**National Fire Protection Association**

**MEMORANDUM**

**TO:** NFPA Technical Committee on Hanging and Bracing of Water-Based Fire Protection Systems

**SUBJECT:** NFPA 13 ROC TC Letter Ballot (A2012)

13\_L1\_Figure #1\_S

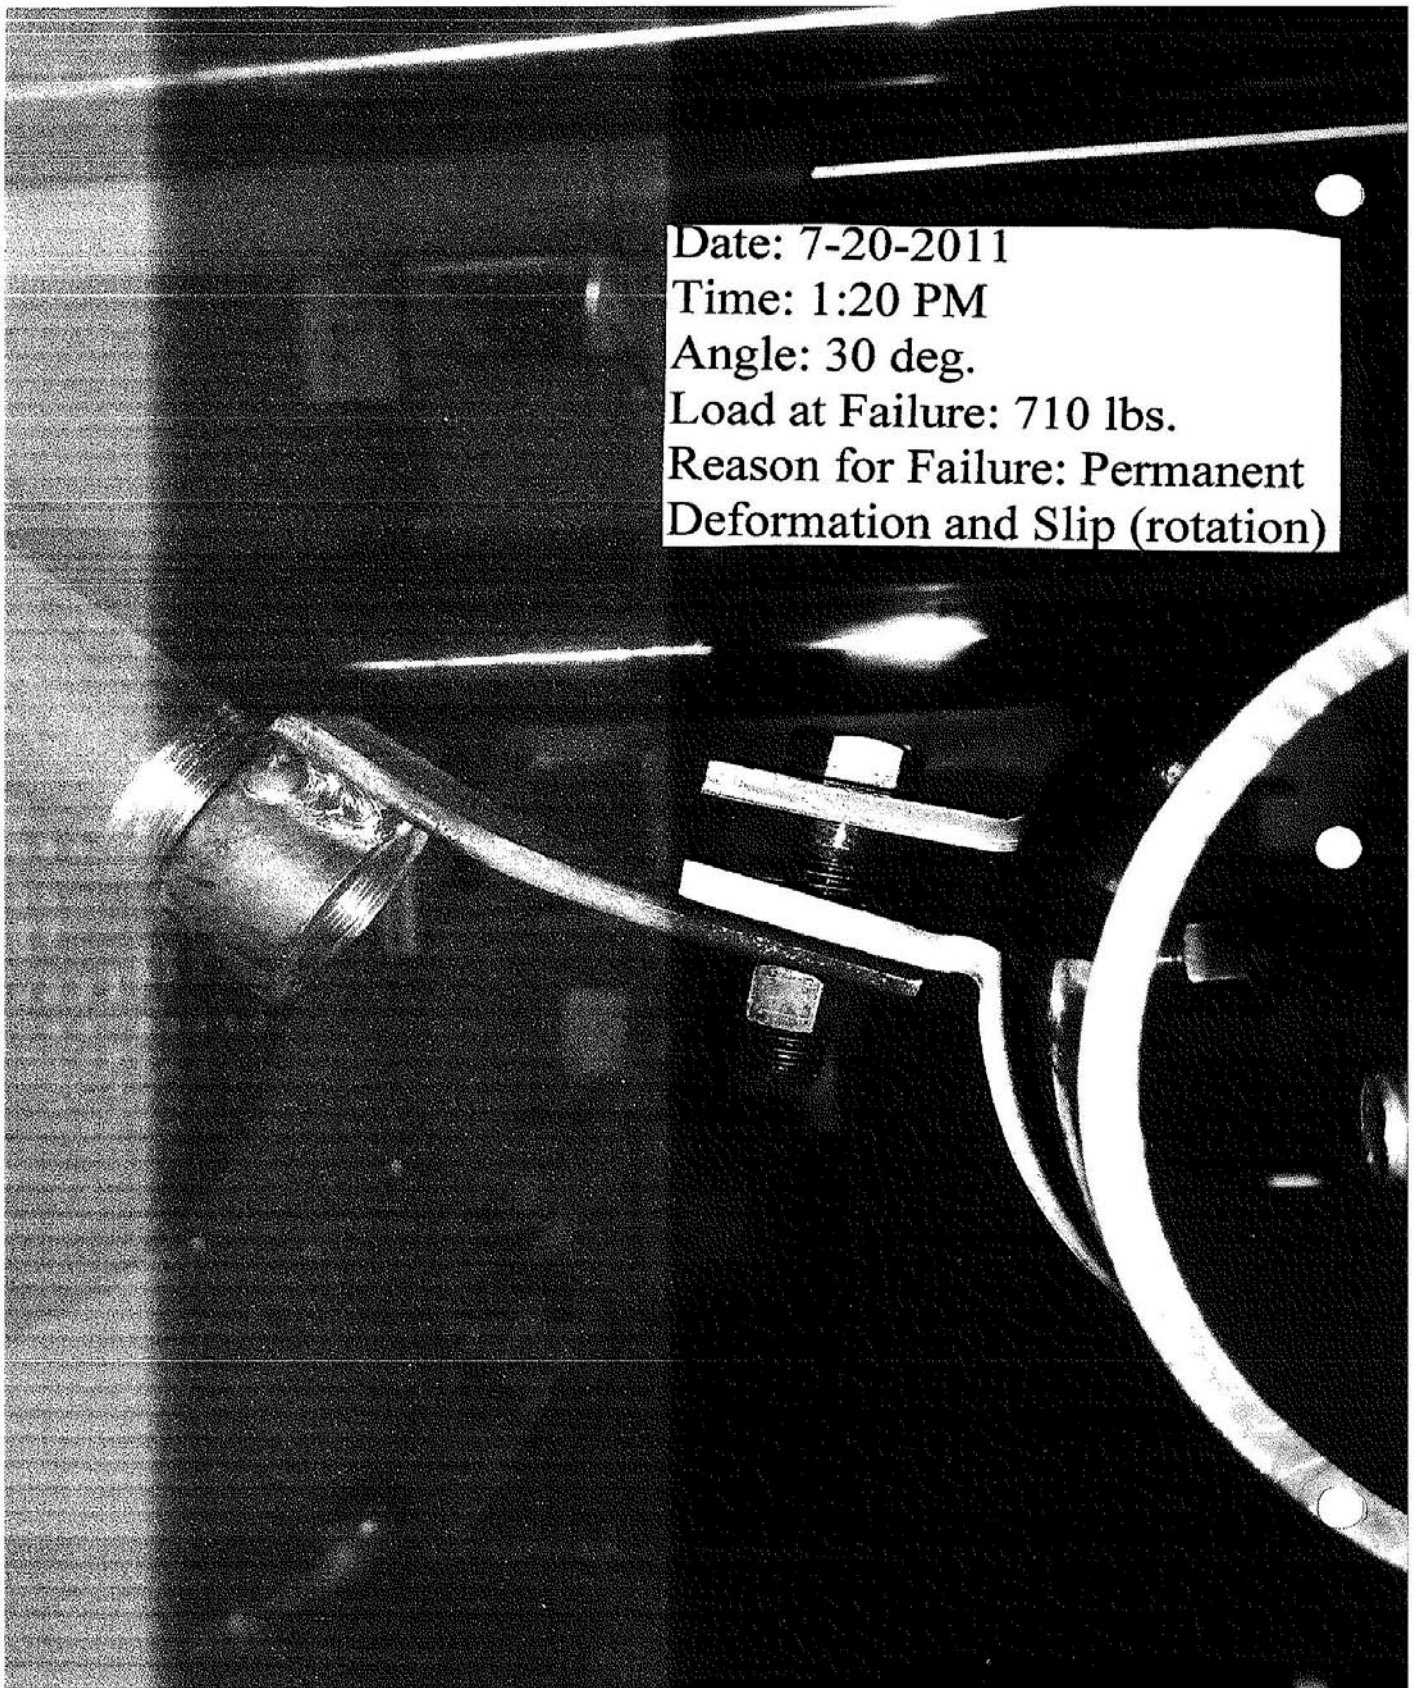
"...tested for listing at maximum eccentricity."

Substantiation: See two additional figures below.

Date: 7-20-2011  
Time: 1:20 PM  
Angle: 30 deg.  
Load at Failure: 710 lbs.  
Reason for Failure: Permanent  
Deformation and Slip (rotation)

13\_L1\_Figure #2\_S

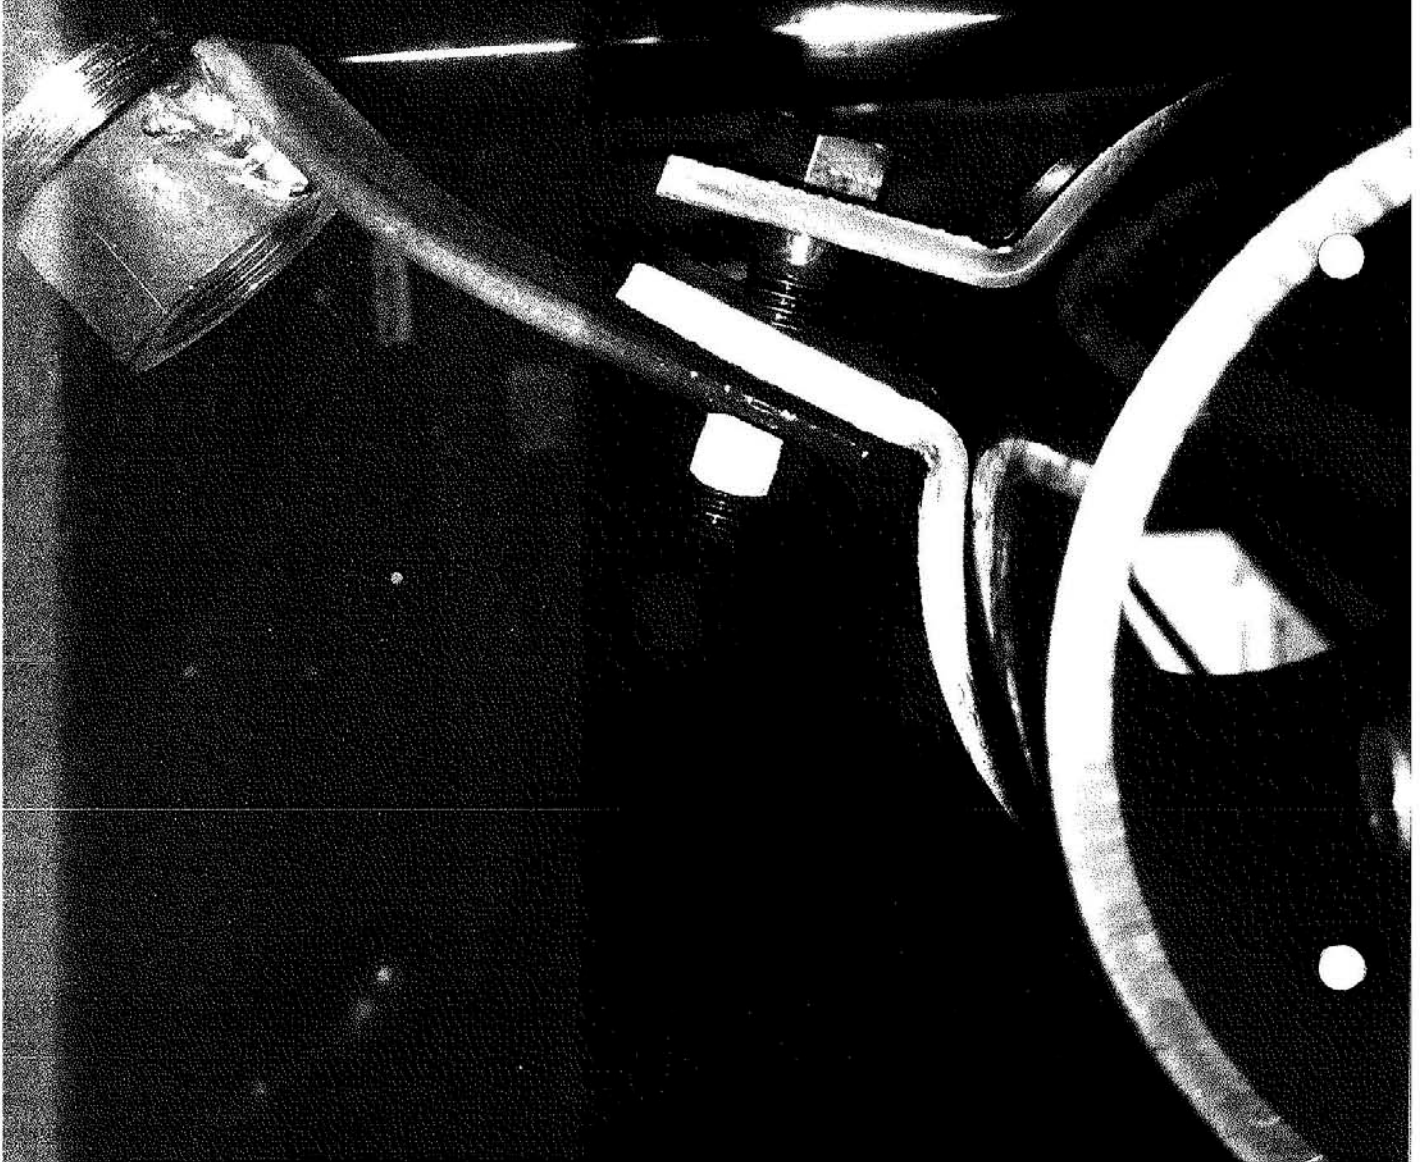
Date: 7-21-2011  
Time: 2.00 PM  
Angle: 45 deg.  
Load at Failure: 980 lbs.  
Reason for Failure: Permanent  
Deformation and Slip (Rotation)
